Product / Process Change Notification (PCN)

PCN Number: PCN_ConMPC3_20241204 Affected Series: WR-MPC3 Affected Order Codes: see table below PCN Date: 2024-09-04 (YYYY-MM-DD) Effective Date: 2024-12-04 (YYYY-MM-DD)	Change Category: ☐ Equipment/Location ☐ General Data ☐ Material ☐ Process ☐ Product Design ☒ Shipping / Packaging ☐ Supplier ☐ Software
Contact: Product Management Phone: +49 (0) 7942 - 945 5001 Fax: +49 (0) 7942 - 945 5179 E-Mail: pcn.eican@we-online.com	Datasheet Change: ☒ Yes ☐ No Attachment: ☐ Yes ☒ No
Description of Change: Due to packaging optimizations, Würth Elektronik eiSos will change the Tube packaging by a Tray packaging. There will be no change in form, fit, function, quality or reliability of the product. The new revision of the affected order codes will be sent out after the previous revision is out of stock (according to FIFO - first-in, first-out).

1. 6620xx2112y

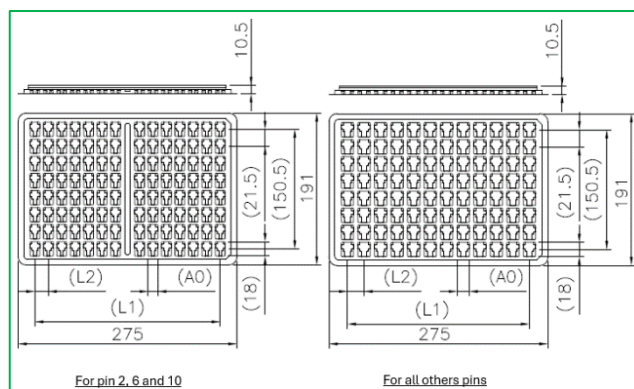
a. Packaging change

BEFORE

AFTER

b. Packaging carton change

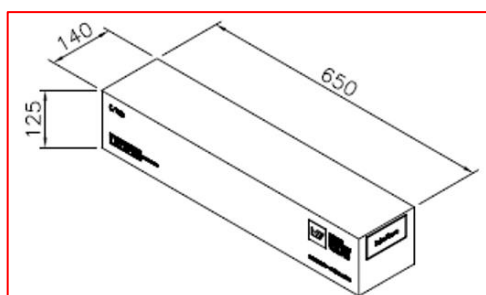
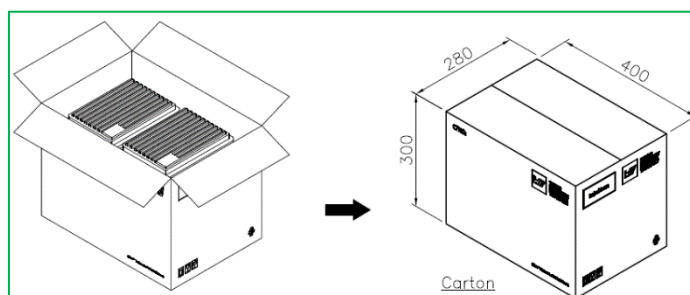
BEFORE

AFTER

2. 6620xx23592y

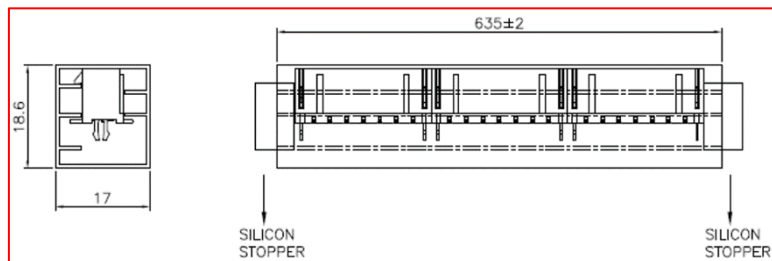
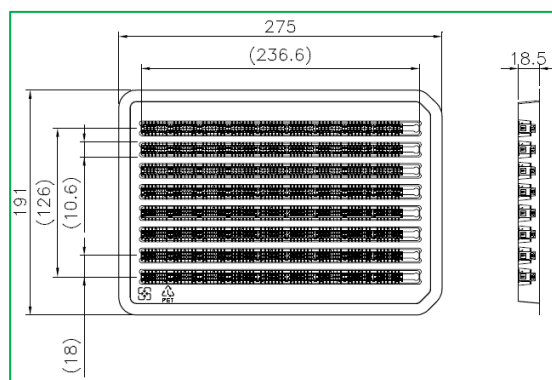
a. Packaging change

BEFORE

AFTER

b. Packaging carton change

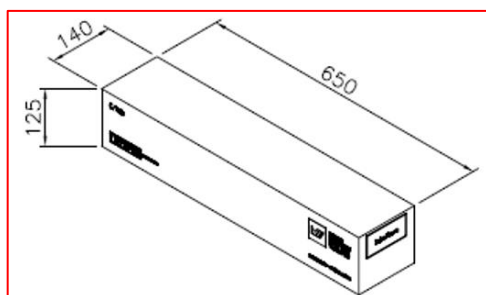
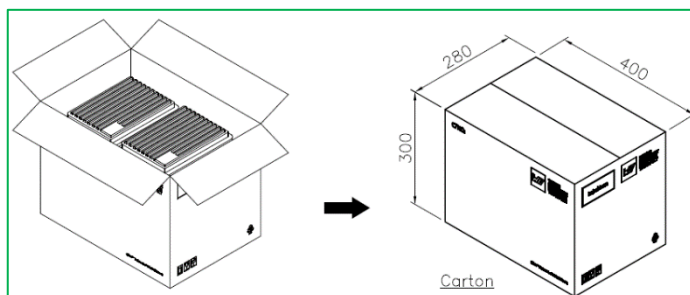
BEFORE

AFTER

3. 6620xx1102y

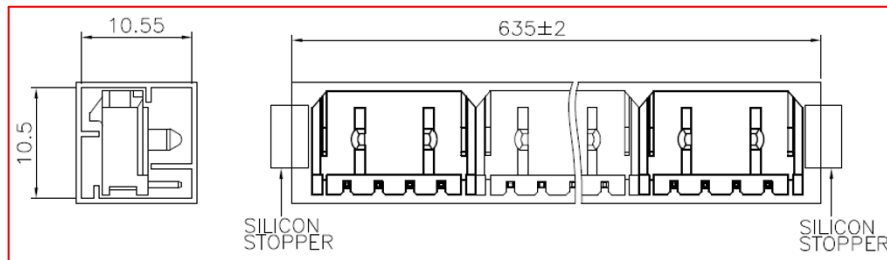
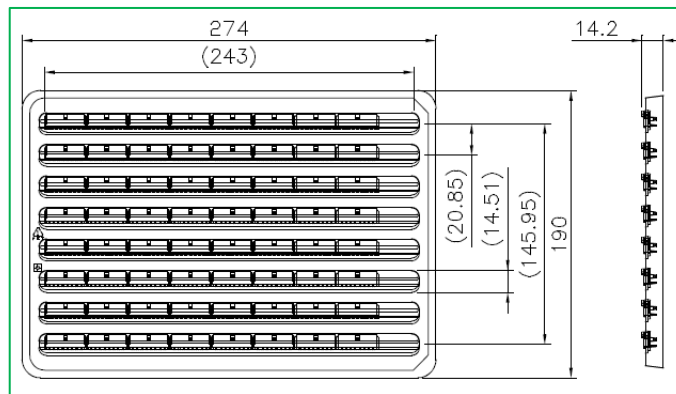
a. Packaging change

BEFORE

AFTER

b. Packaging carton change

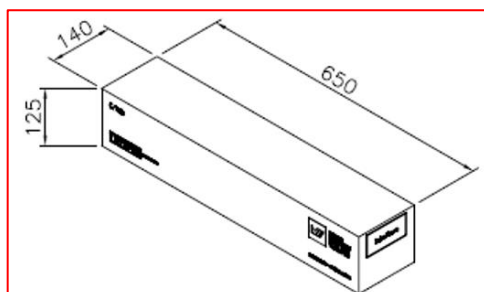
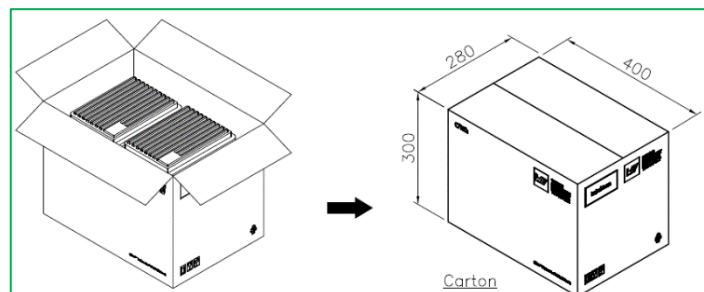
BEFORE

AFTER

4. 6620xx1112y

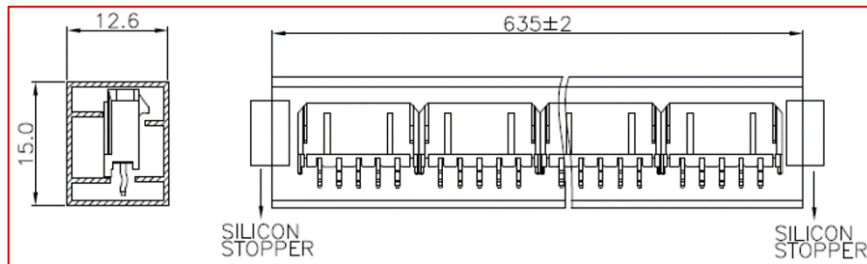
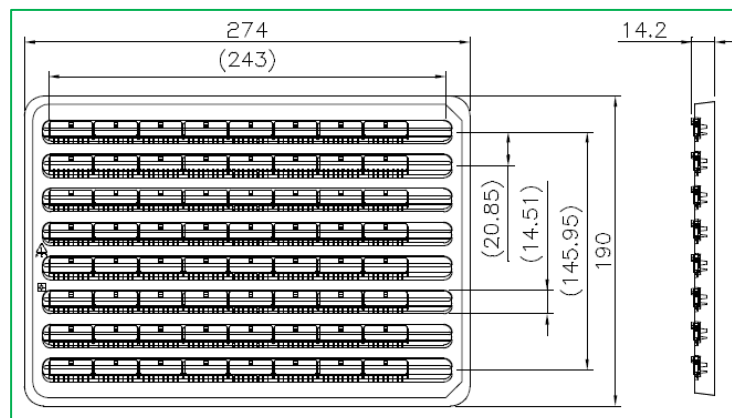
a. Packaging change

BEFORE

AFTER

b. Packaging carton change

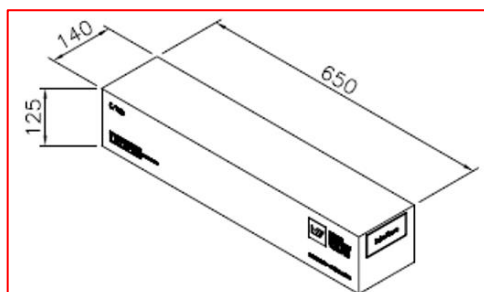
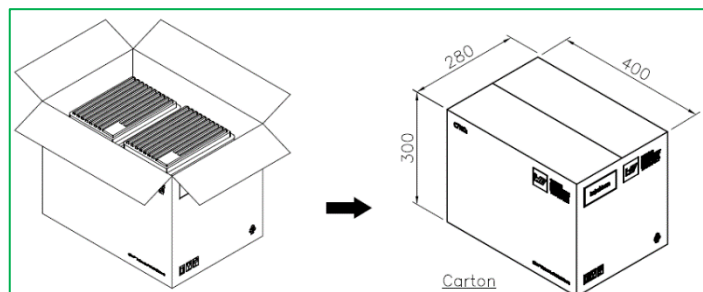
BEFORE

AFTER

5. 6620xx23082y

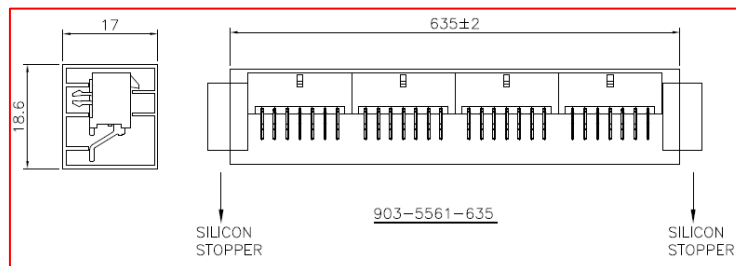
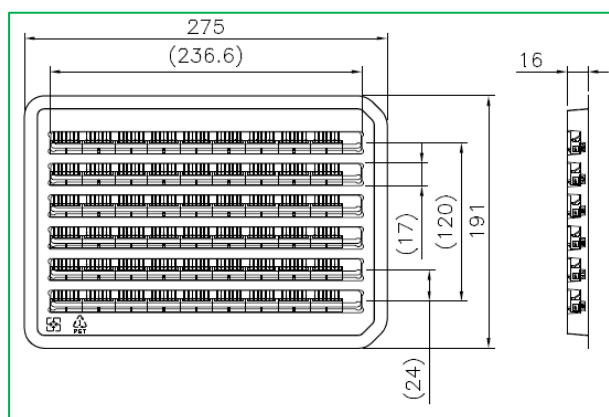
a. Packaging change

BEFORE

AFTER

b. Packaging carton change

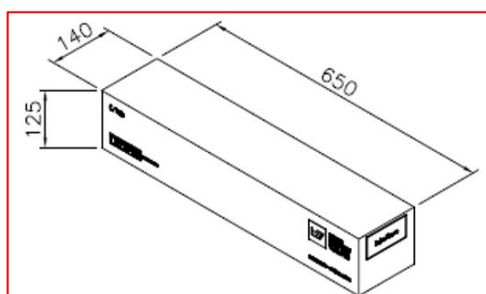
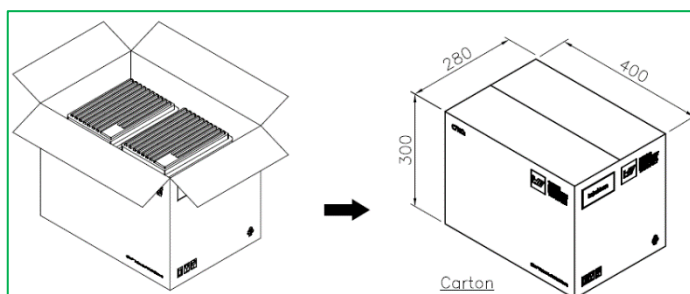
BEFORE

AFTER

6. 6620xx23602y

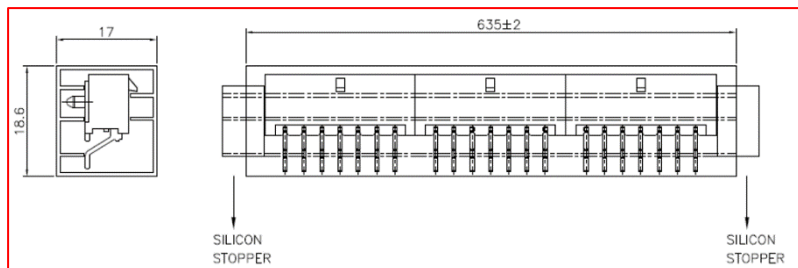
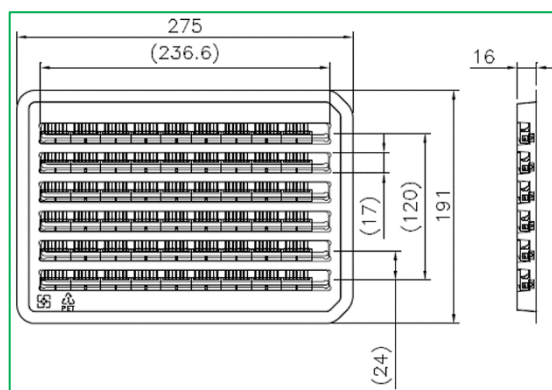
a. Packaging change

BEFORE

AFTER

b. Packaging carton change

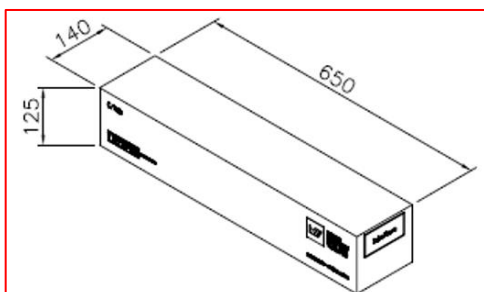
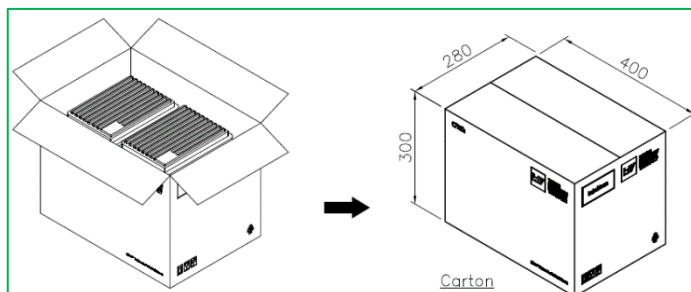
BEFORE

AFTER

7. 6620xx2102y

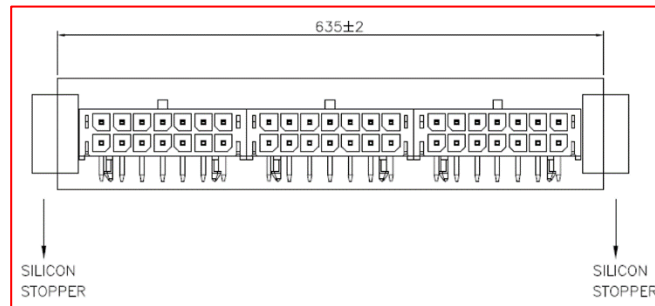
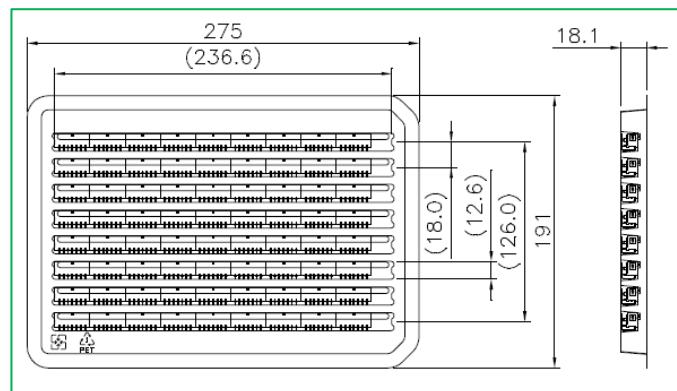
a. Packaging change

BEFORE

AFTER

b. Packaging carton change

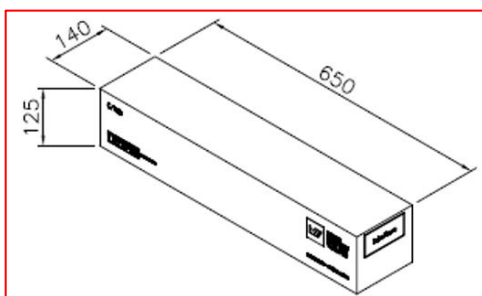
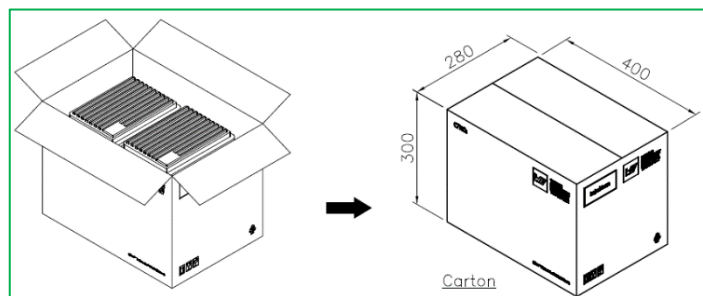
BEFORE

AFTER
